TITLE : FUSELAGE - FUSELAGE AFT SECTION - CHANGE FASTENER AT FR91

This page transmits Revision No. 01 of Service Bulletin No. A310-53-2126.

SERVICE BULLETIN No. : A310-53-2126

REVISION No. : 01 - May 31/07

Figure 1 Sheet 1
Config. 01 thru 02: Replacement of the Fasteners

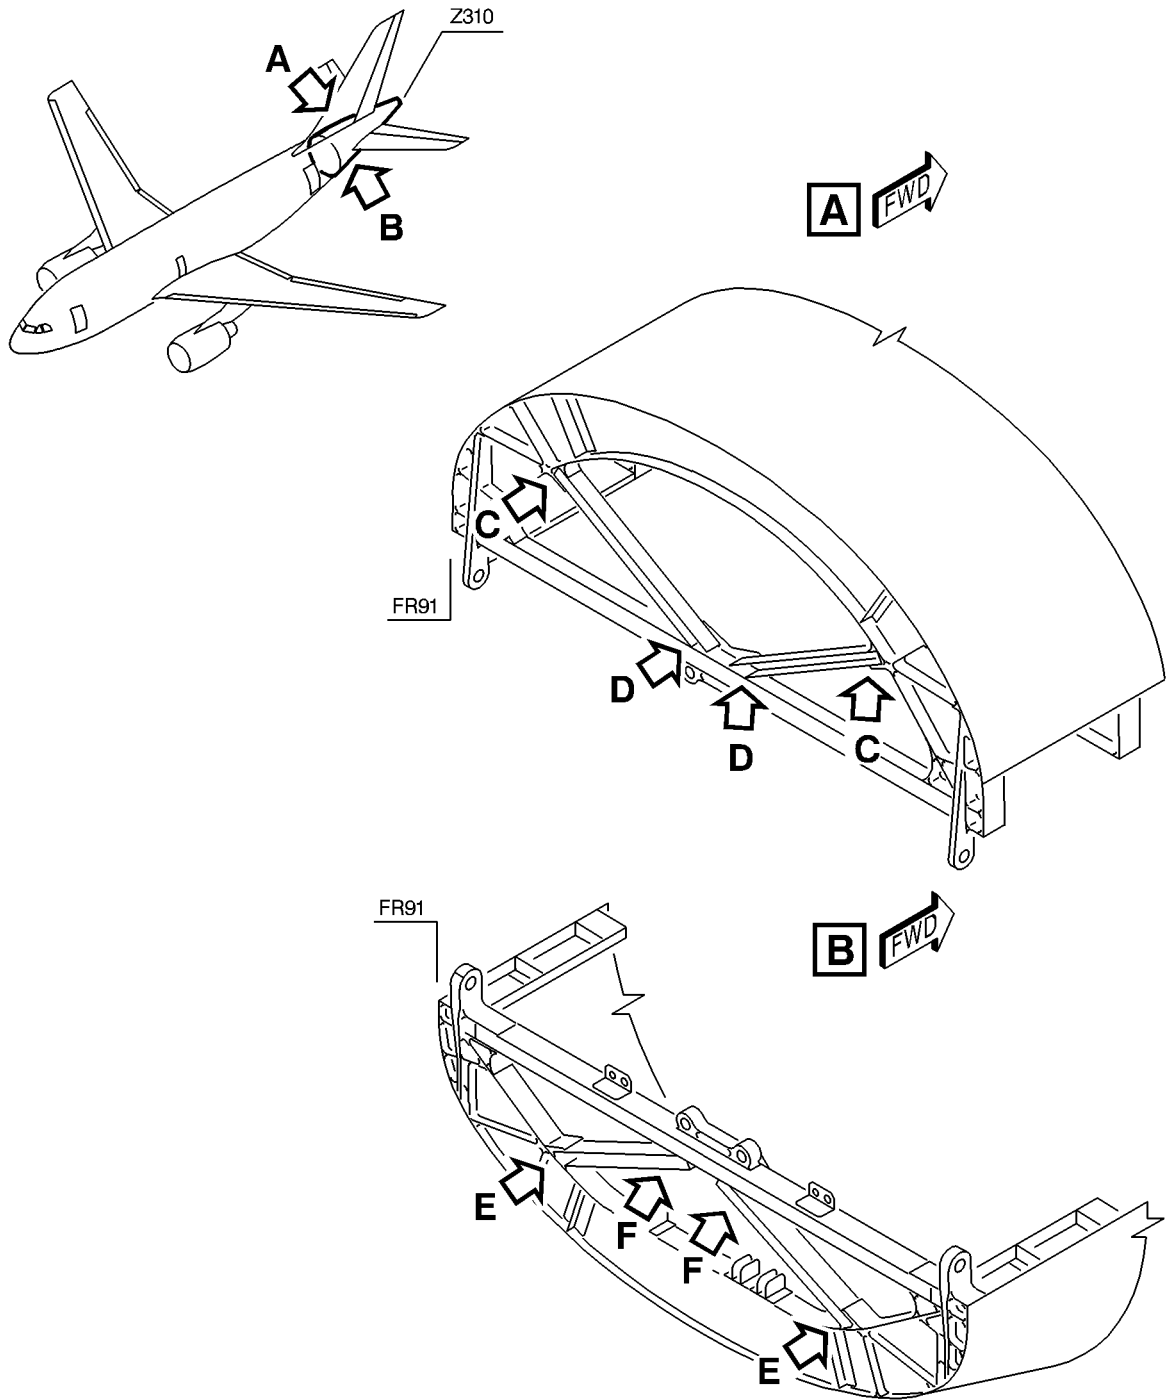
- (a) Replace the fasteners in the upper support struts at FR91, LH and RH.

- 1 Replace the fasteners at the upper attachments of the upper support struts at FR91.

Figure 1 Sheet 2
Config. 01 thru 02: Replacement of the Fasteners

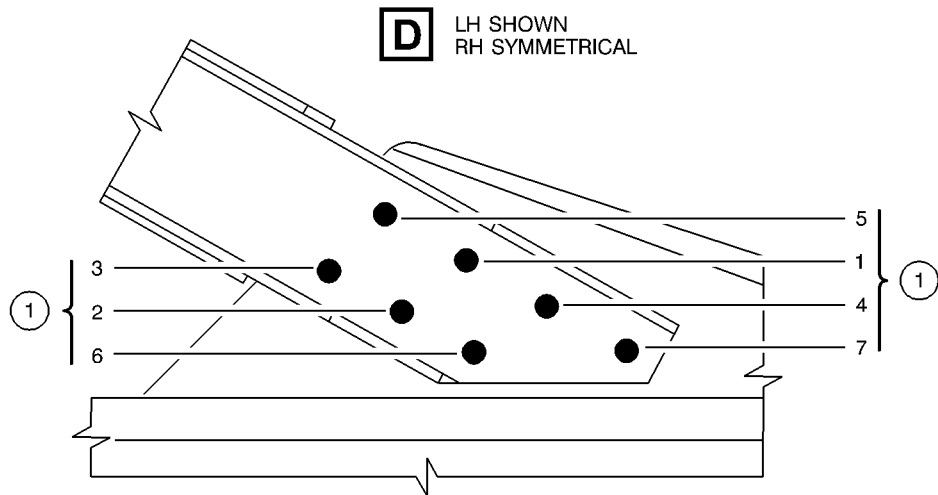
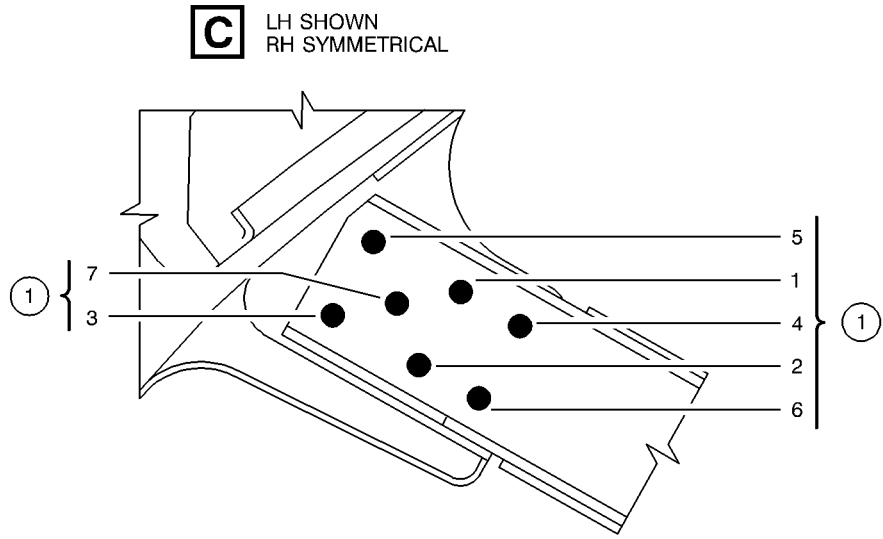
Refer to Figure 1 , Sheet 1 and Sheet 2 , Detail C.

Refer to Figure 1 , Sheet 1 and Sheet 2 , Detail D.

Figure 2 Sheet 1
Config. 03: Replacement of the Fasteners

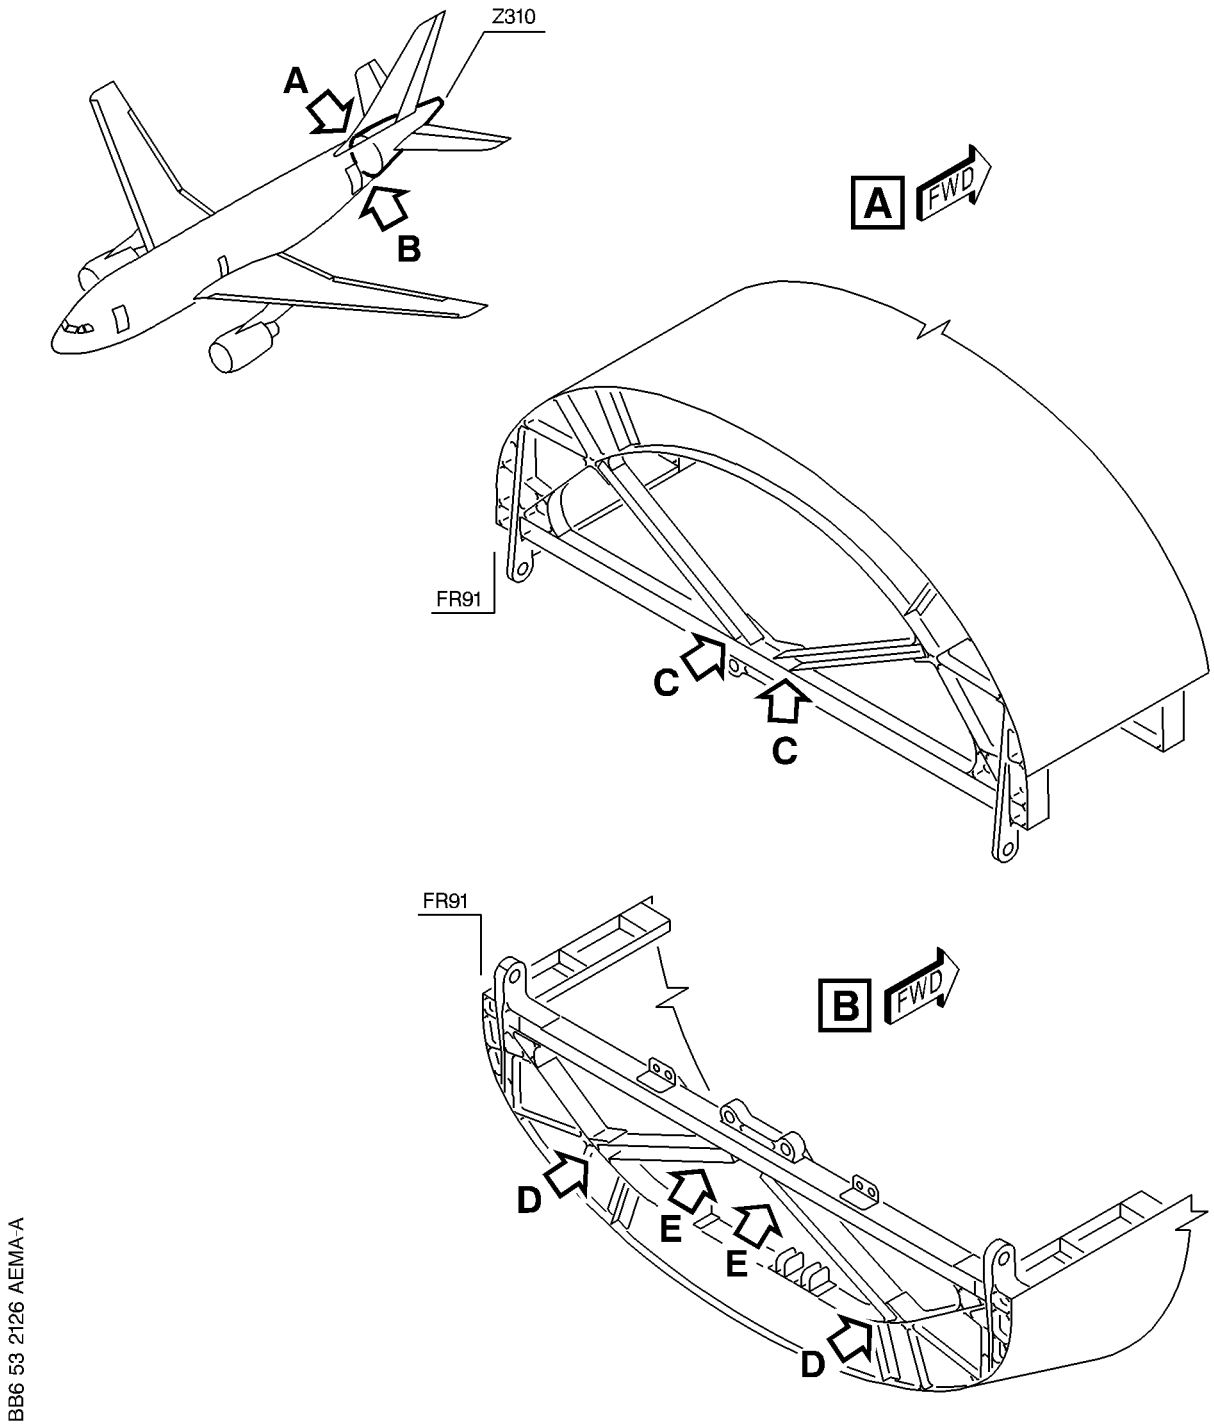
(a) Replace the fasteners in the upper support struts at FR91, LH and RH.

1 Replace the fasteners at the lower attachments of the upper support struts at FR91.

Figure 2 Sheet 2
Config. 03: Replacement of the Fasteners

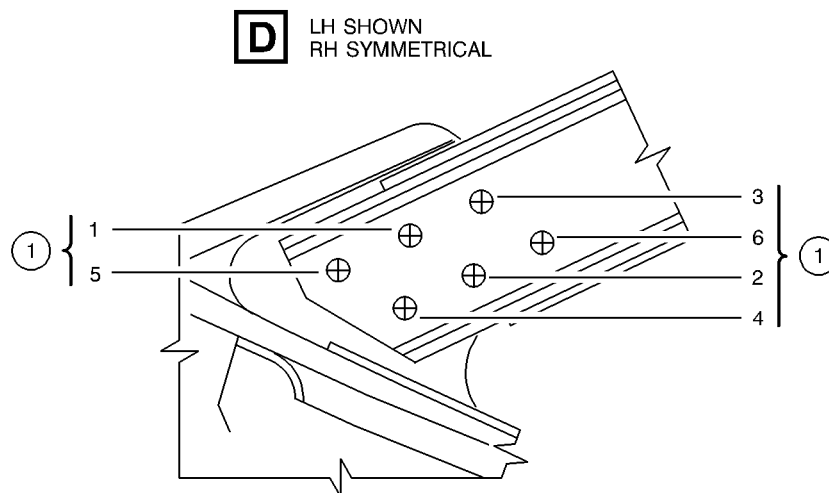
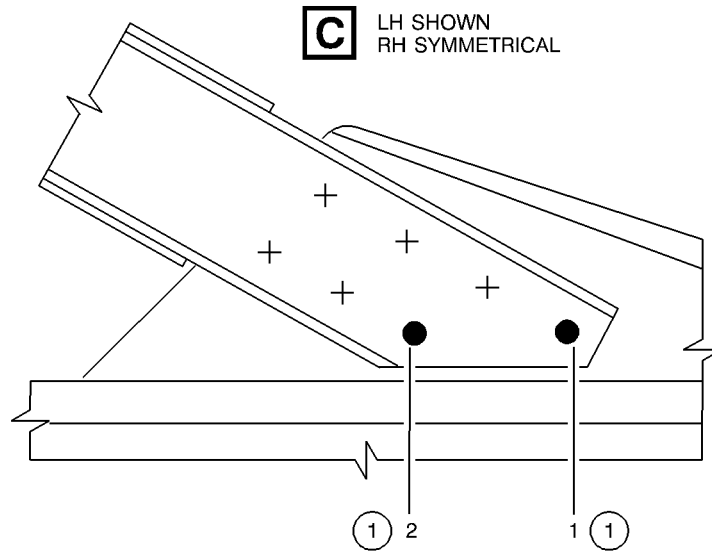
Refer to Figure 2 , Sheet 1 and 2 , Detail C.

Refer to Figure 2 , Sheet 1 and Sheet 2 , Detail D.

Figure 3 Sheet 1
Config. 02: Reinforcement of the Upright Support Struts at FR87

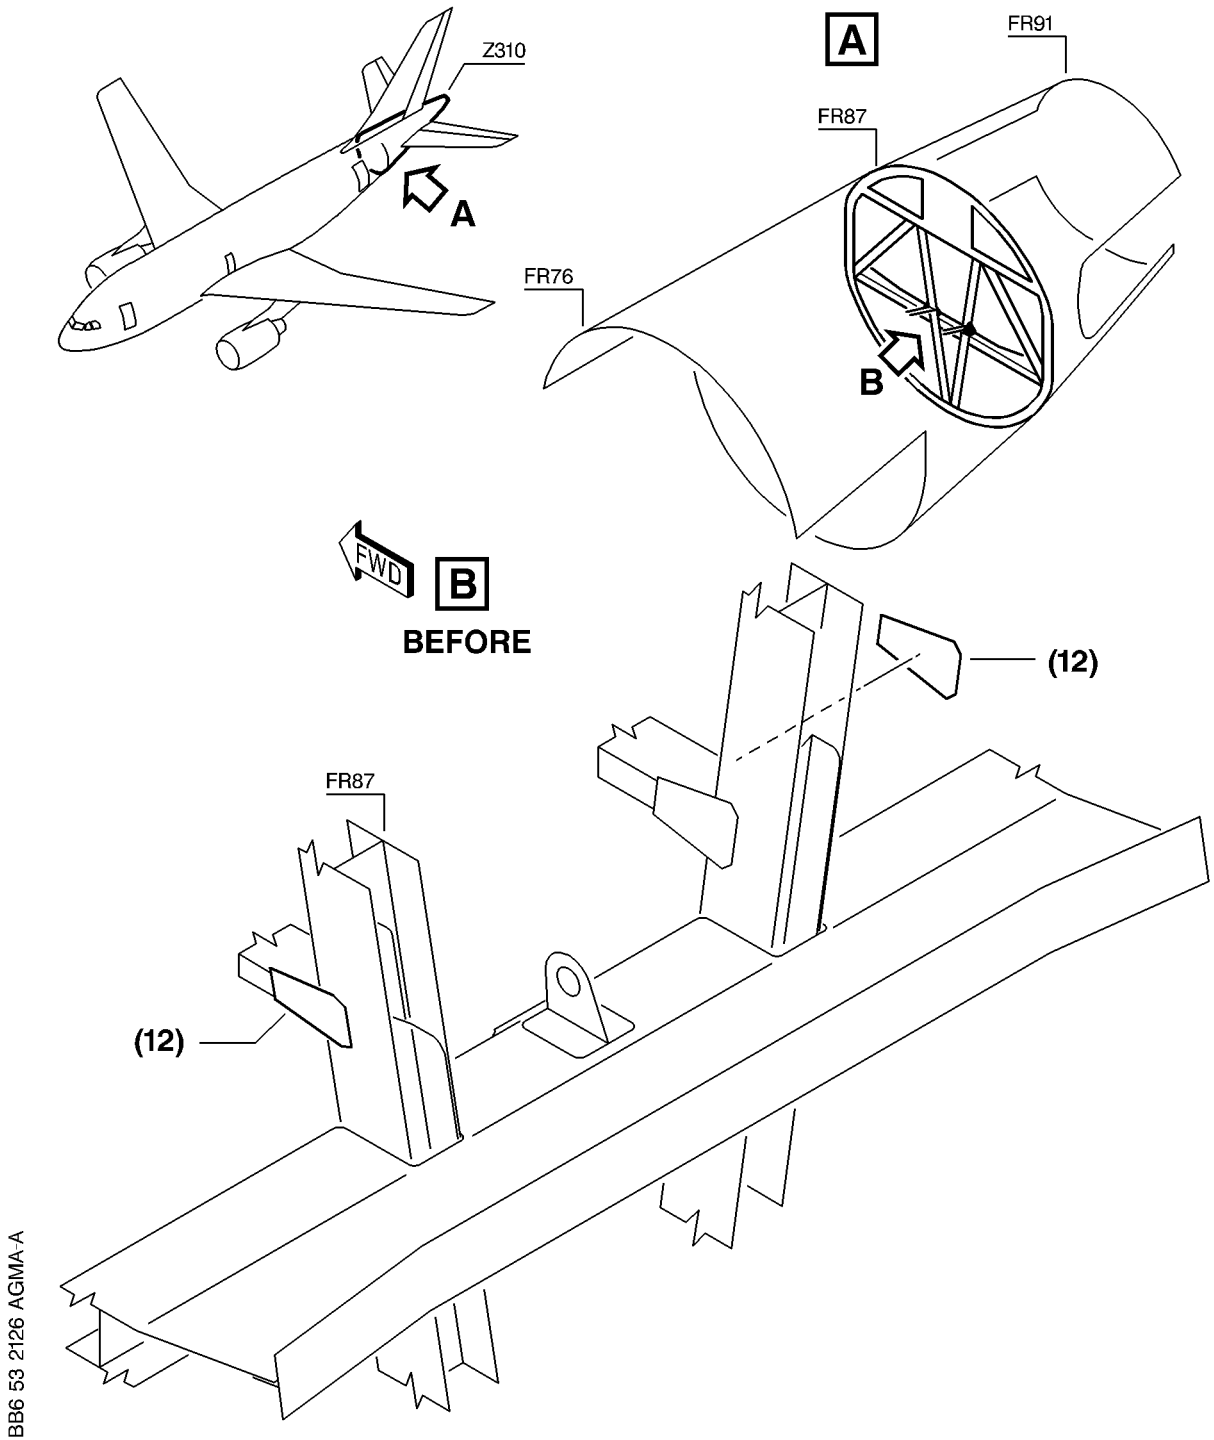
- 1 At FR87, remove from the LH and RH upright support struts :

Refer to Figure 3 , Sheet 1 , Detail B, BEFORE.

Figure 3 Sheet 2
Config. 02: Reinforcement of the Upright Support Struts at FR87

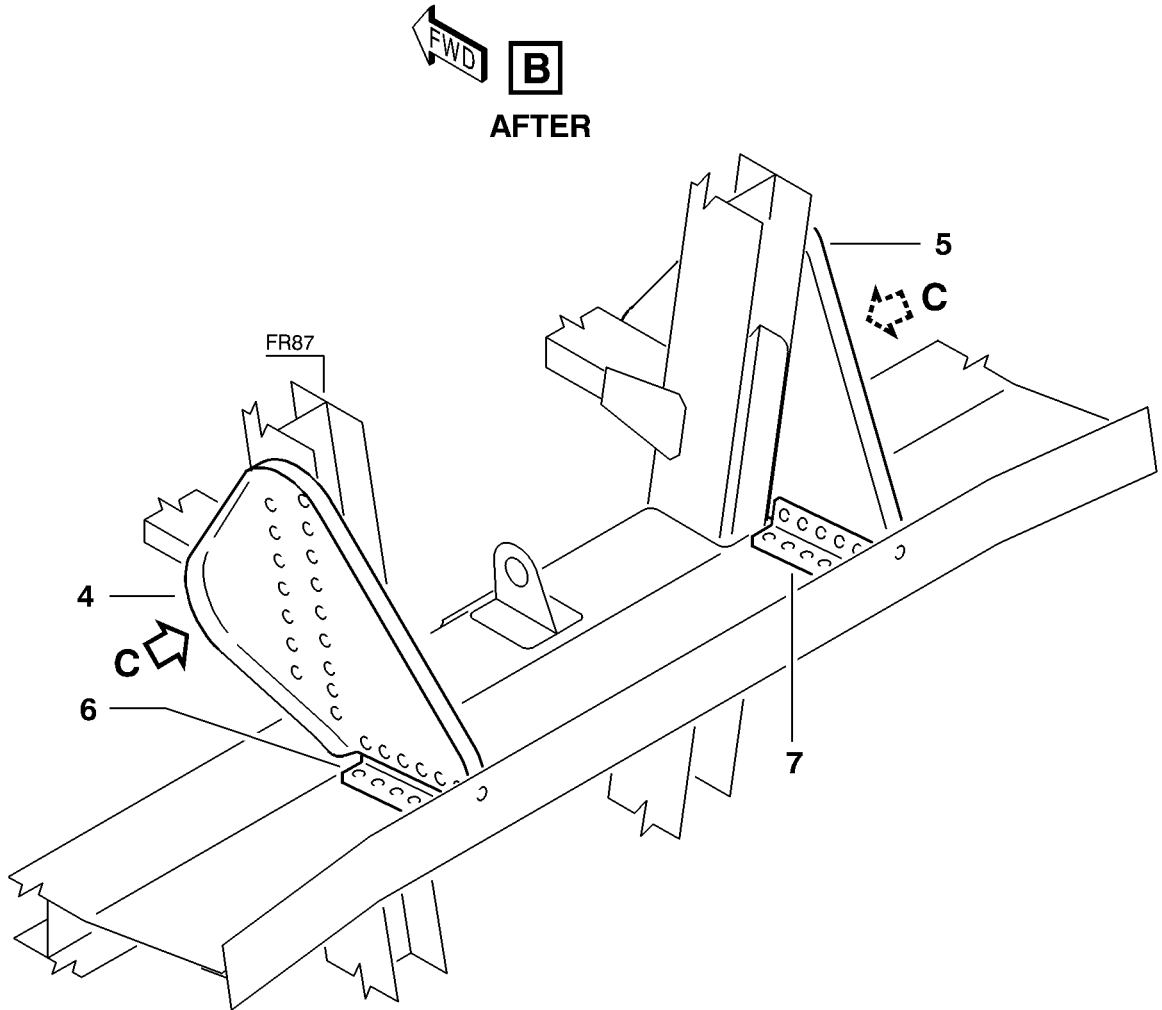
Refer to Figure 3 , Sheets 2 thru 4

Figure 4 Sheet 1
Config. 02: Reinforcement of the Diagonal Support Struts between FR87 and FR91

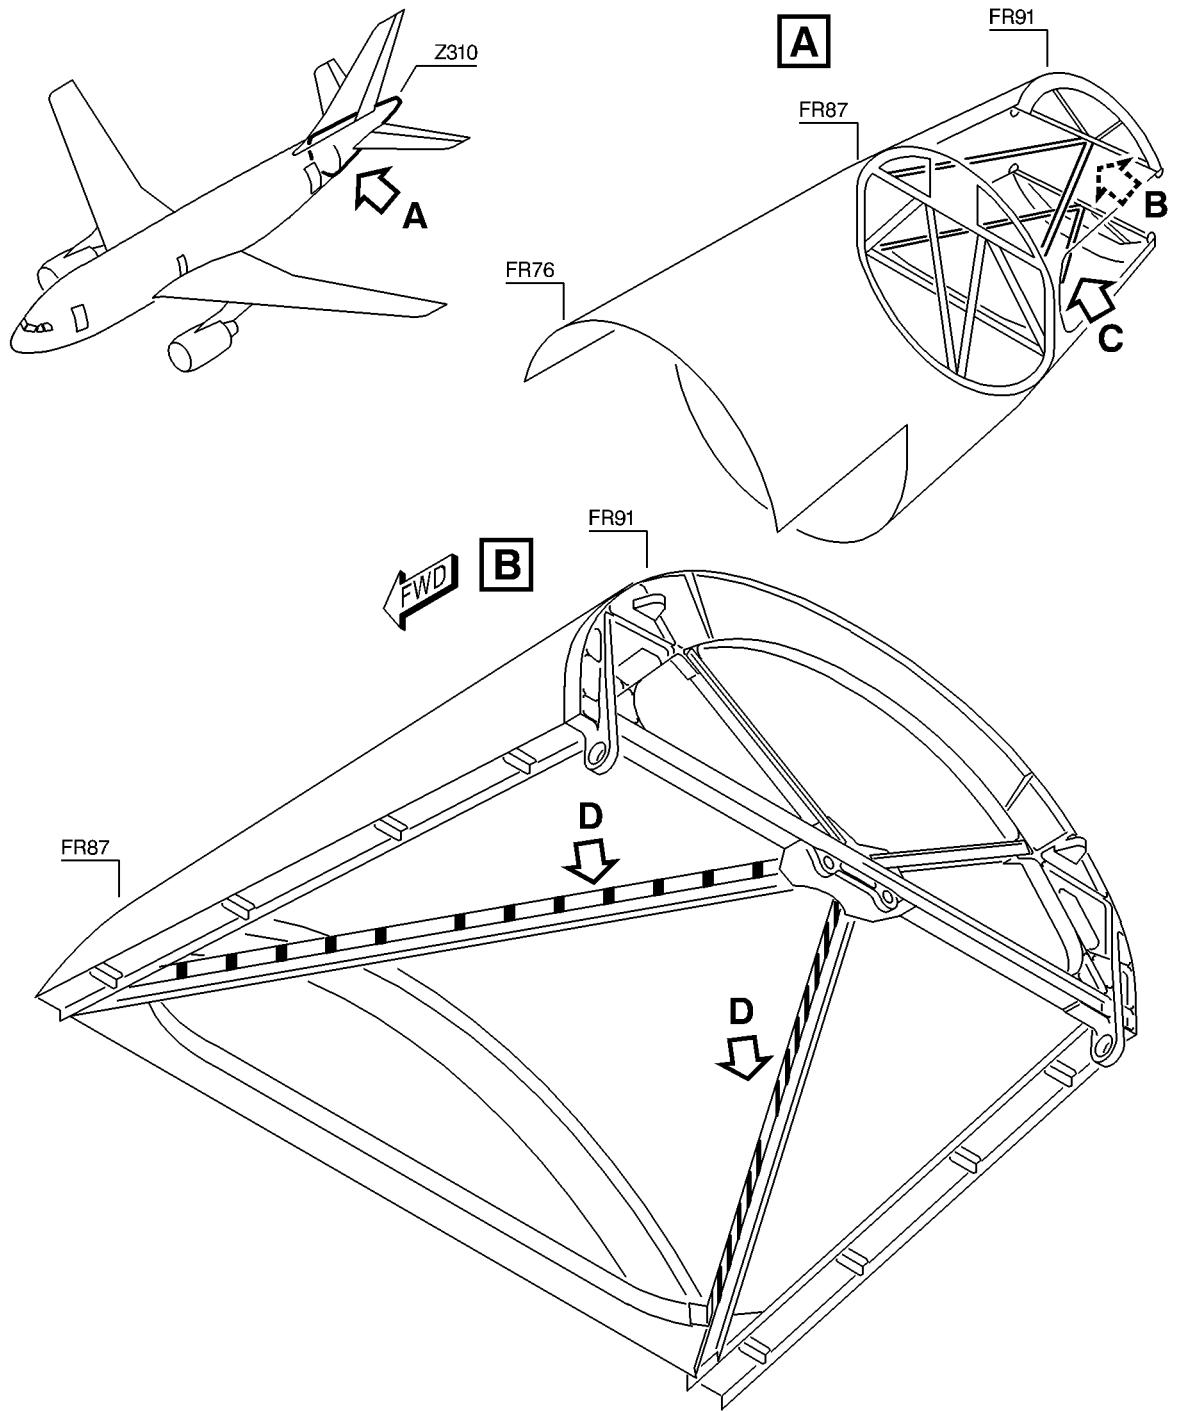
Refer to Figure 4 , Sheet 1 and Sheet 3

Figure 4 Sheet 2
Config. 02: Reinforcement of the Diagonal Support Struts between FR87 and FR91

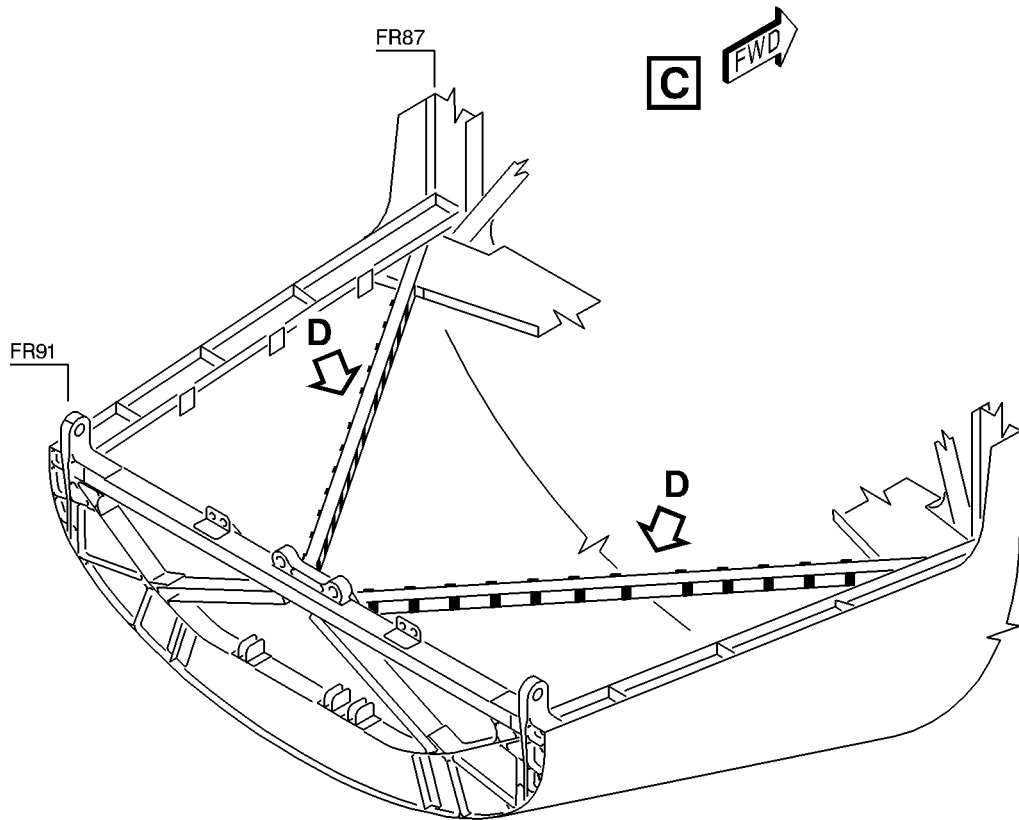
Refer to Figure 4 , Sheet 2 and Sheet 3
